Gurnell Leisure Centre Meeting Note

GLA Pre-Application Workshop

14th December 2017

Agreed Indicative Layout:

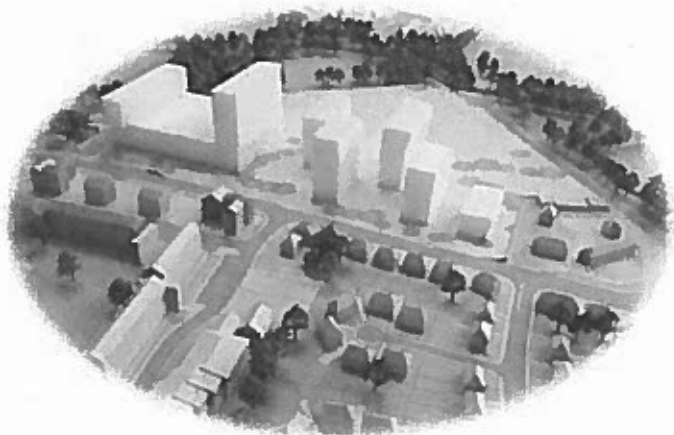
- A 'u-shaped' block was considered above the leisure centre – however it was concluded that it created problems with the swimming pool span / structure, north facing units and reducing openness with the 'super-structure' form.

- Two linear buildings running north-south either side of the leisure centre box, have least impact on the function of the leisure centre (pool) and minimise / reduce north facing units. This was considered the appropriate design response. In addition, it was considered the two linear buildings above the leisure centre knitted better with the fingers blocks to the east in terms of layout, helping draw the two parts of the site together visually.

- Taller buildings are better suited in the middle of the scheme, where they have least impact on neighbours and can have a large amount of public realm to provide a better setting. Specifically, [REDACTED] considered that Block B, i.e. the eastern block on top of the leisure centre, should be the taller element of Blocks A and B.

- The staggering of buildings with 3 blocks at the front and 2 at the rear provide a good balance of utilising the existing PDL and providing permeability and a sense of openness.

- Measurement of existing and proposed PDL / building footprint will be key and this needs further detailed work in terms of loss / gain, notably for Block C. [REDACTED] appeared willing to accept the improvement to the MOL by moving the leisure centre block forward, versus the 'creep' into the MOL of the proposed fingers blocks, i.e. the principle of a 'land swap'.

- [REDACTED] noted that they were really encouraged by the progress made.
- Opposite is a photo of the outcome of the workshop.
- Enclosed is a pack of information with further details of site constraints and the outcome of the workshop prepared by 3DReid dated 14th December 2017.
